# 2010 Review and Evaluation of the Shiprock Remediation Strategy

January 2011

**2010 Review and Evaluation  
of the Shiprock Remediation Strategy**

Attachment 1 Area-Specific Matrix Summarizing Key Aspects of the 2010 Midterm Strategy Evaluation	
Appendix A Responses to Stakeholder Comments

Figure 5. Decrease in Groundwater Elevations in Terrace Alluvial Wells (March 2003—March 2010)

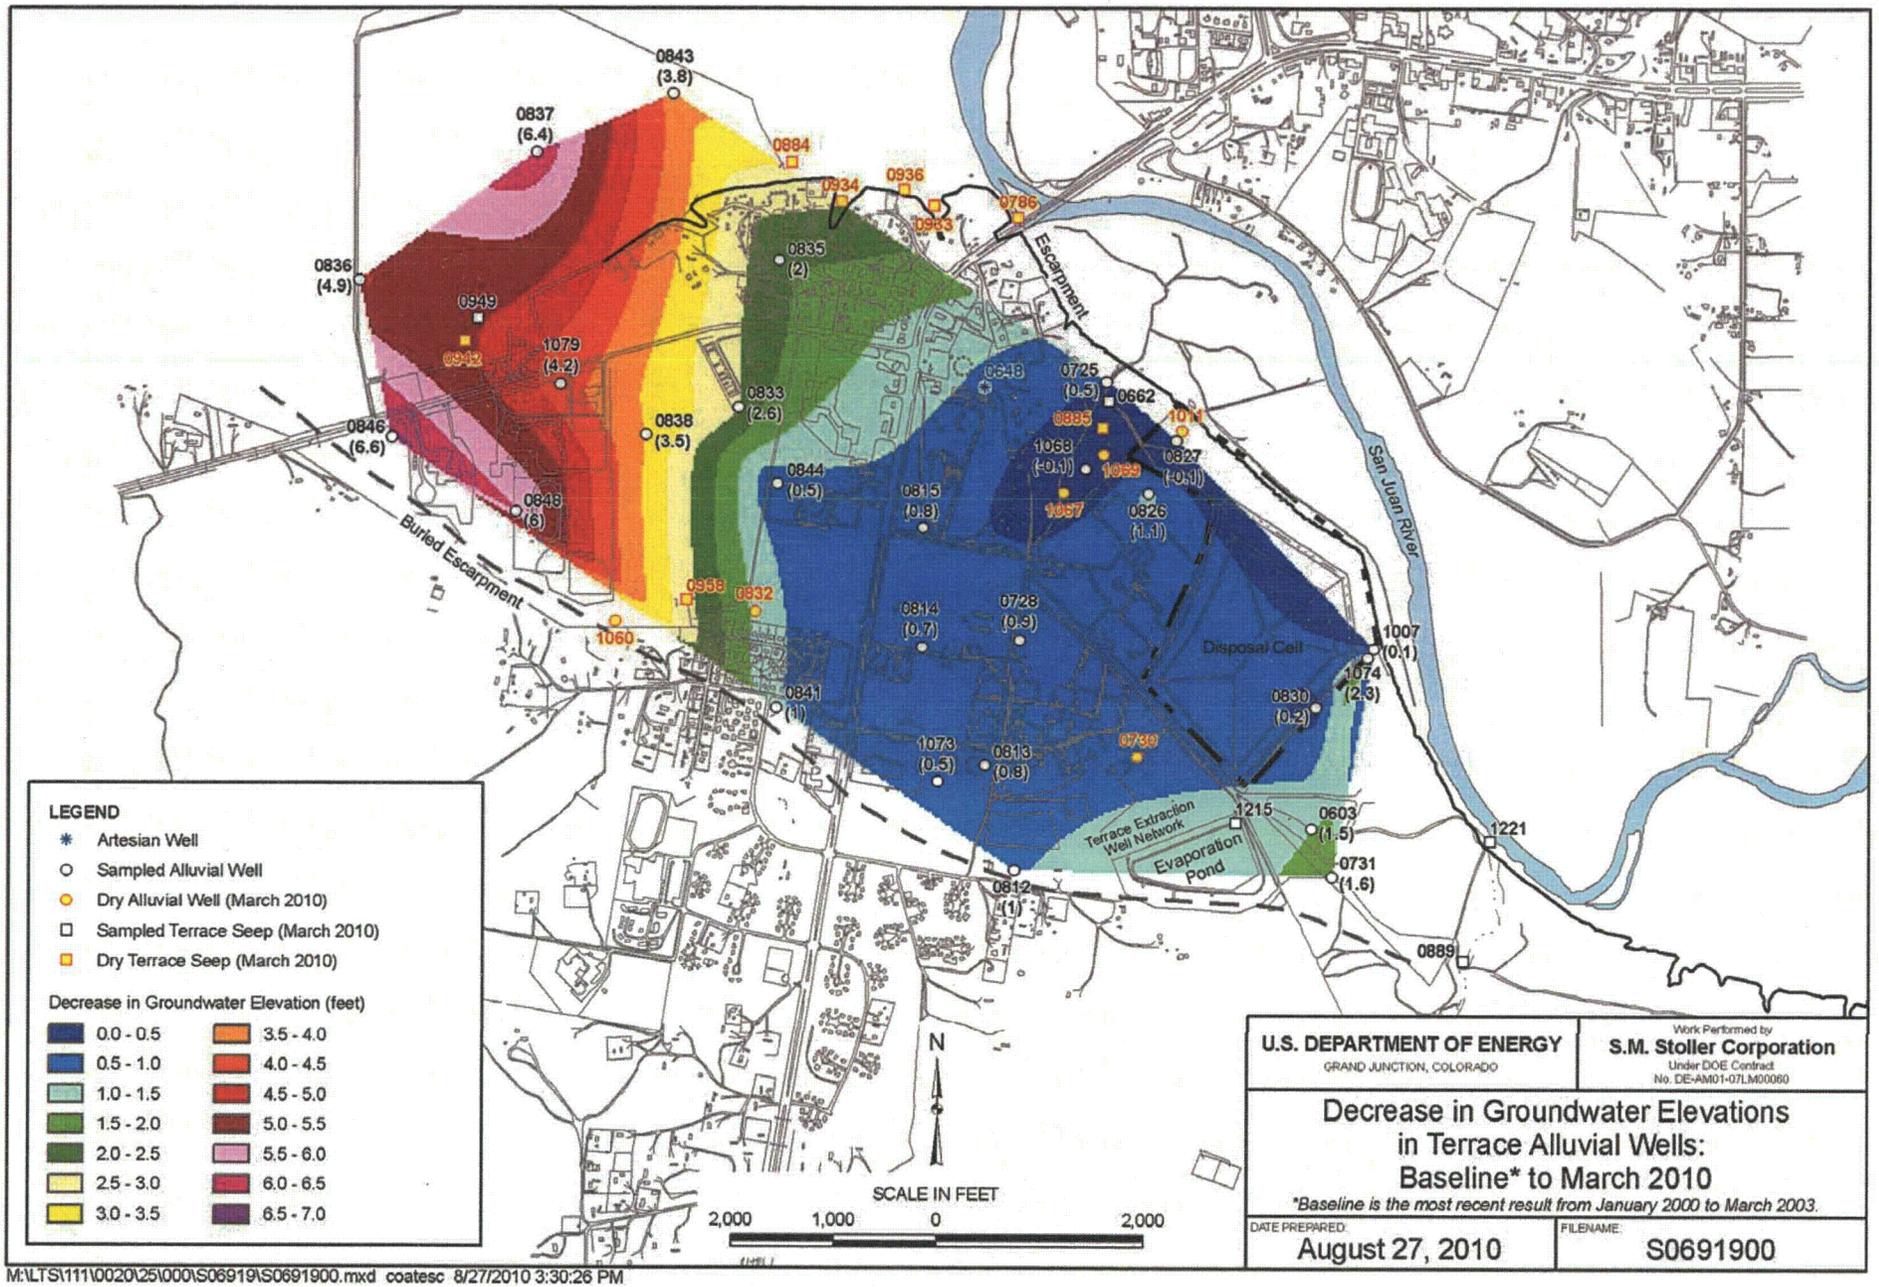
**Comment 4.** In paragraph 3 states that several monitoring wells and the environmental sampling data was utilized to evaluate the potential of adding wells to the remediation system, regardless of the past environmental data the DOE should have obtained water level measurements at all ground water monitoring wells prior to stating water levels are declining in the terrace.

DOE monitors water levels at most wells on a semiannual basis. Figure 5 of the revised strategy evaluation demonstrates the declines in terrace water levels for the subset of alluvial wells for which baseline (before March 2003) measurements are available.
